## Access Compliance Report Public Rights-of-Way (Curb Ramps)

Intersection ID: 31083 Main Street: BROOKINGS\_DR Cross Street: TAUTEN\_CT Location: SE

ADA ID: C58EDAB807D4 Ramp Type: PerpDiag Initial Pass/Fail: Pass Overall Compliance: No Severity Score: 21.5

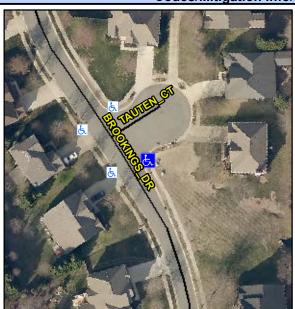
Compliance Description Data Compliance Description Data Yes N/A Ramp Length (in) 52.0 Ramp Slope (%) 5.7 Yes Ramp XSlope (%) Yes Ramp Width (in) 48.0 1.7 N/A Flare Type LT Sloped N/A Flare Type RT N/A N/A N/A Flare Slope RT (%) Flare Slope LT (%) 9.6 12.9 N/A Flare Traversable LT? No N/A Flare Traversable RT? No No 44.0 No DWS Provided? Landing Length (in) No No Landing Width (in) 35.0 N/A **DWS Contrast?** No N/A No Landing Slope (%) 3.5 DWS Length (in) N/A N/A No Landing X Slope (%) 3.0 DWS Full Width? No N/A Landing Curb? (Y/N) No N/A DWS Offset (in) N/A N/A Shared Landing? No Gutter Ponding? Yes Gutter Slope (%) No Yes 0.6 No Gutter Lip Ht (in) 0.5 Yes Gutter X Slope (%) 1.4 N/A Painted X Walk1? No N/A Painted X Walk2? No X Walk 1 Direction To W X Walk 2 Direction To N N/A N/A X Walk 1 Width (in) N/A X Walk 2 Width (in) N/A X Walk 1 Slope (%) X Walk 2 Slope (%) 7.0 3.8 X Walk 1 X Slope (%) 3.8 X Walk 2 X Slope (%) 2.9 N/A N/A N/A Ramp inside XWalk2? N/A Ramp inside XWalk1? Road Slope (%) 0.3 N/A Clear Space? Yes N/A Road X Slope (%) 6.0 Clear Space to XWalk (in) N/A No Yes Any Obstructions? Yes Storm Grate/Utility Hazard? No **Obstruction Type** Storm Grate/Utility Type

TATUTEN CT StopSign BROOKINGS DR None Remove & Replace Curb Ramp With Two New Directional Ramps or Equivalent. Grind Gutter Lip.

R304.2.1, R304.2.2-Perp, R304.3.2-Para, R304.5.3, R305, R302.7, R302.7.2
